BLOOMINGTON HISTORIC PRESERVATION COMMISSION

Thursday April 12, 2012

AGENDA

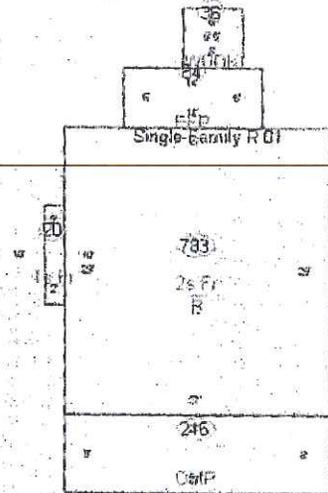
This assessors survey shows the original foot print of the house (the front porch faces west)
 It l shows the footprint of the removed porch. The new addition (visible only from the alley) will be 16 X 8 and contained a half bath and closet on one side. The width of the house is approximately 27'.

EXISTING

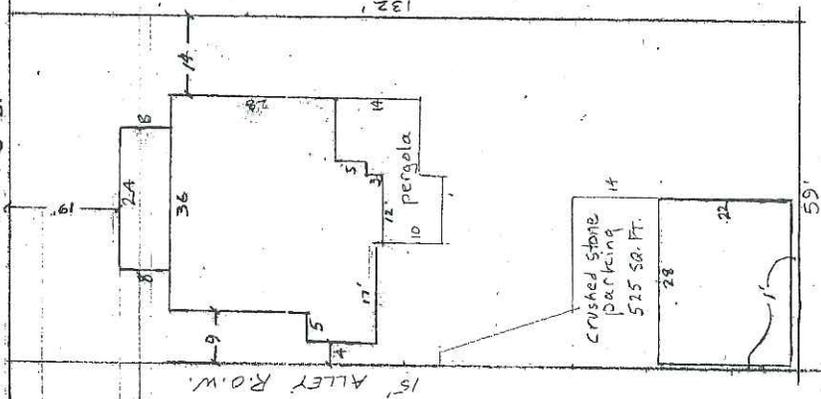
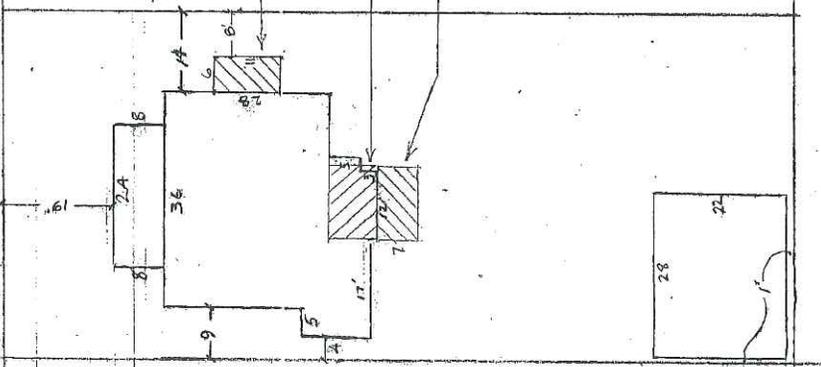
Bathroom Addition

Room to be Reconstructed

New Roofed Porch

Staff recommends approval of COA-11-12 with the condition that the petitioner's receive the appropriate approvals from Plan Commission and the Board of Zoning Appeals

SOUTH ELEVATION
VIEW FROM BACK YARD
1/2" = 1'

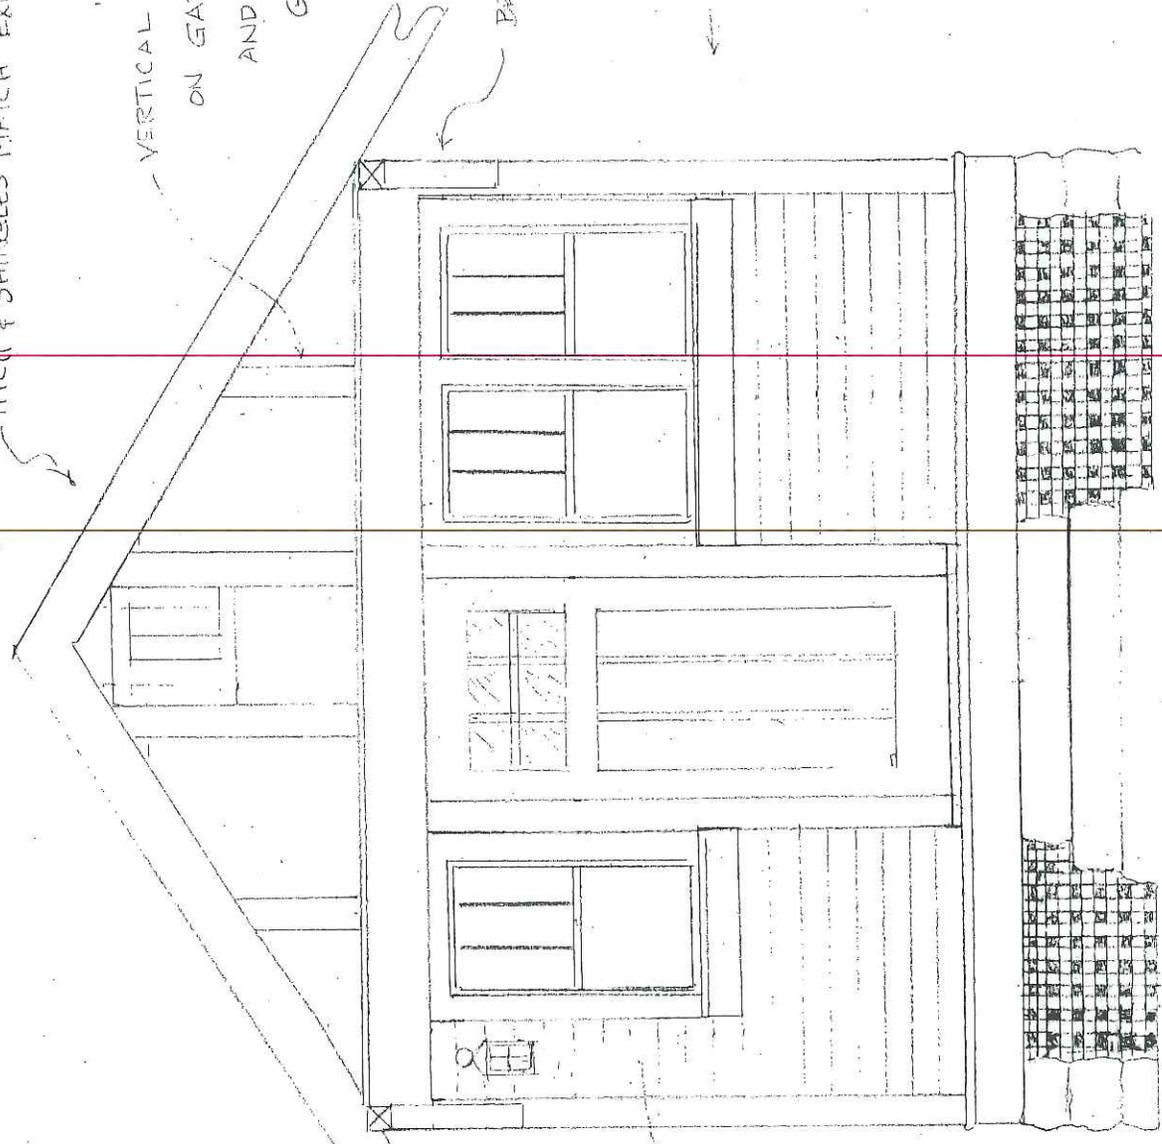
PITCH & SHINGLES MATCH EXISTING

VERTICAL TRIM REPEATED
ON GABLE OF ROOM
AND ON OPEN PORCH
GABLE

BRACKETS AS ON FRONT

← DARK STAINED WOOD DOOR

WEST ELEVATION

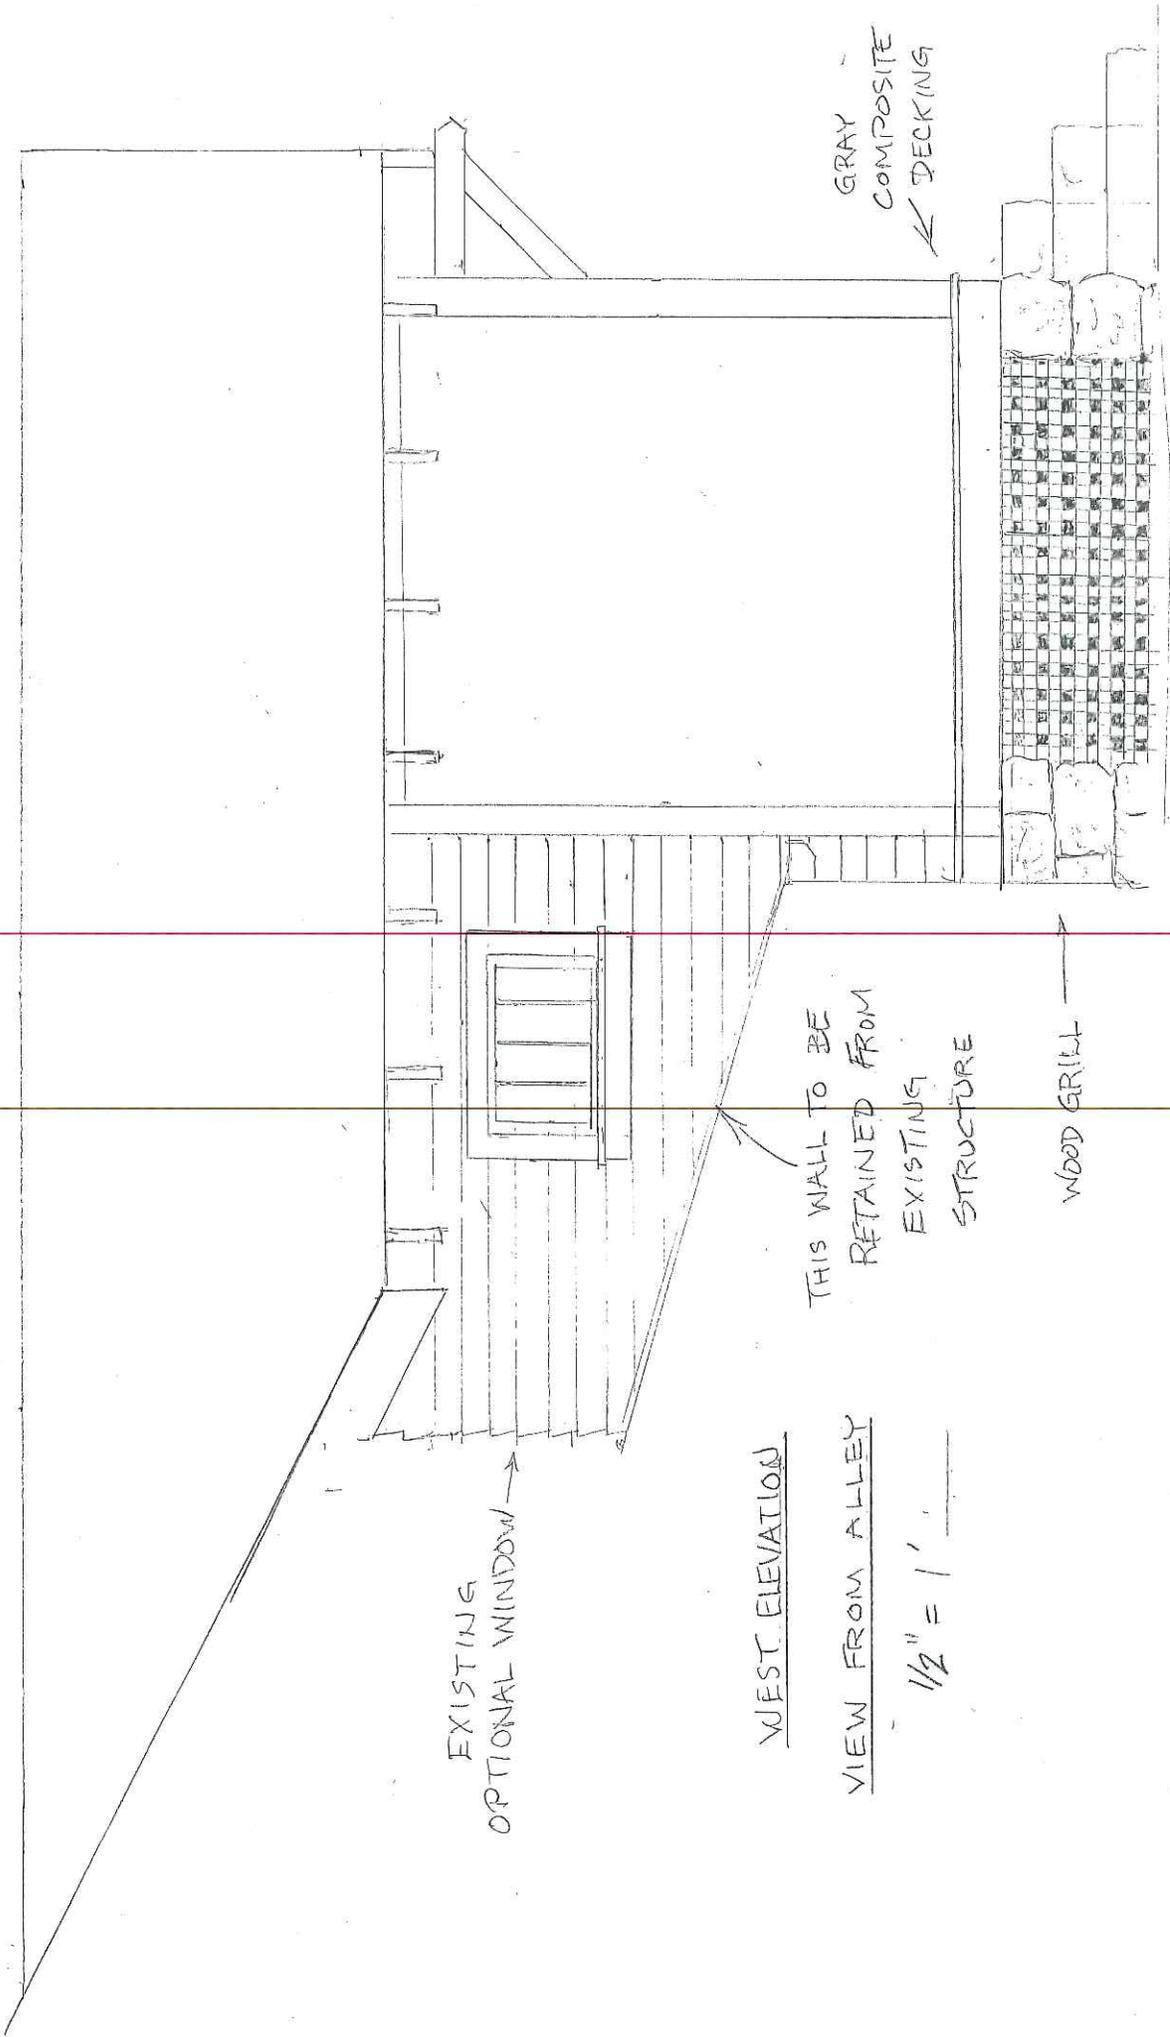
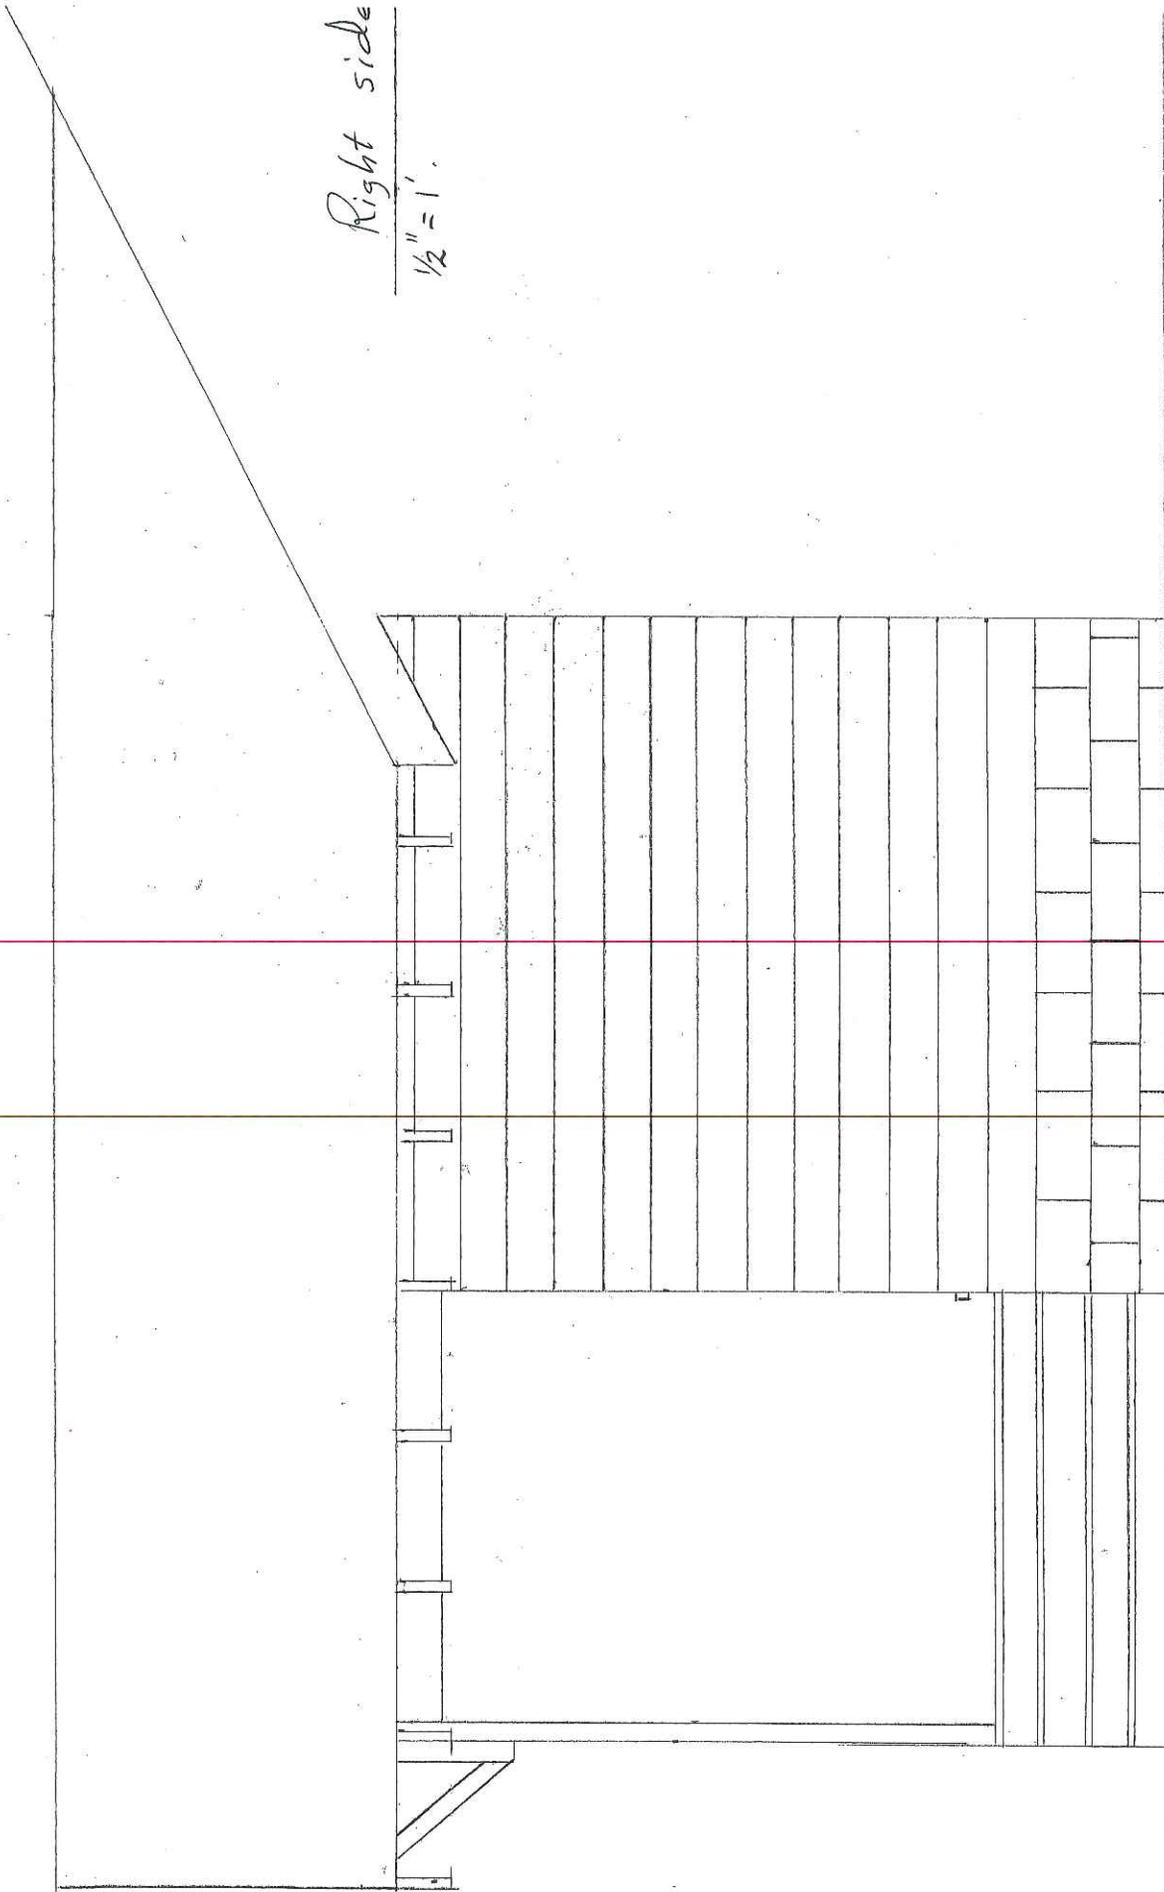
ALTERNATIVE:
SPACE 3 WINDOWS
TO FILL WALL
WIDTH

EXISTING
OPTIONAL WINDOW →

THIS WALL TO BE
RETAINED FROM
EXISTING
STRUCTURE →

GRAY
COMPOSITE
DECKING →

WOOD GRILL →

EAST ELEVATION
VIEW FROM SIDEYARD

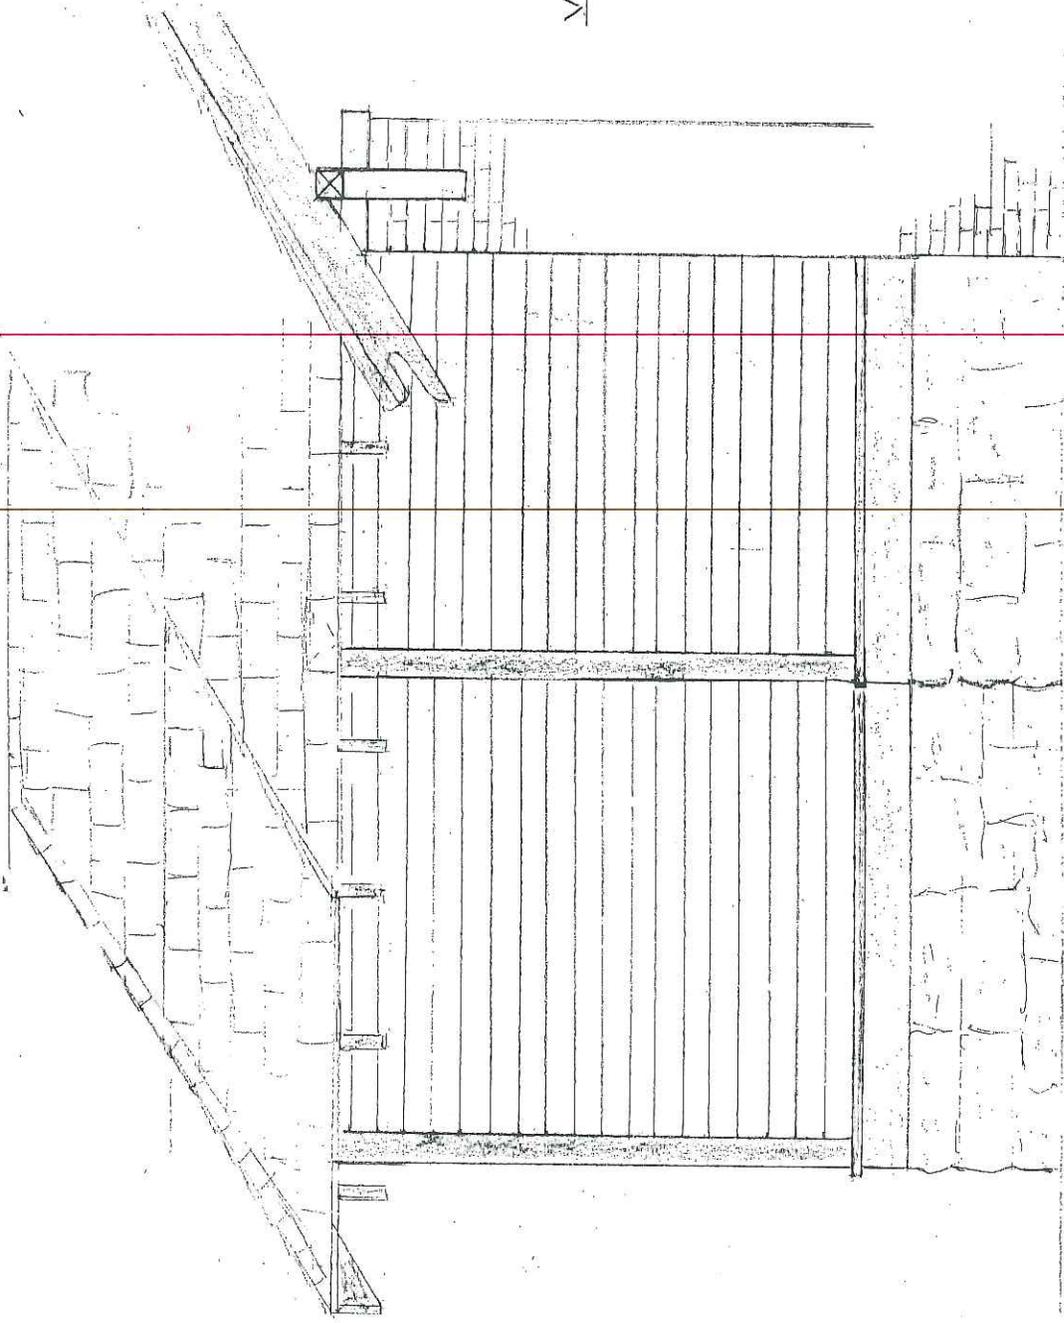
Non-original window to be removed.

Hip style roof to lower profile.

Limestone to match walls and foundation where visible.

HIP ROOF - MATCH EX. SHINGLES

11' x 6.5' ADDITION

The bathroom addition is generated by a need to make the bath area accessible to an aging relative. The hipped roof, is a graceful way to accommodate the interior space, and it is supported by the arts and crafts framing details proposed. Proposed materials are in compliance with accepted norms for additions on wood clapboard houses.
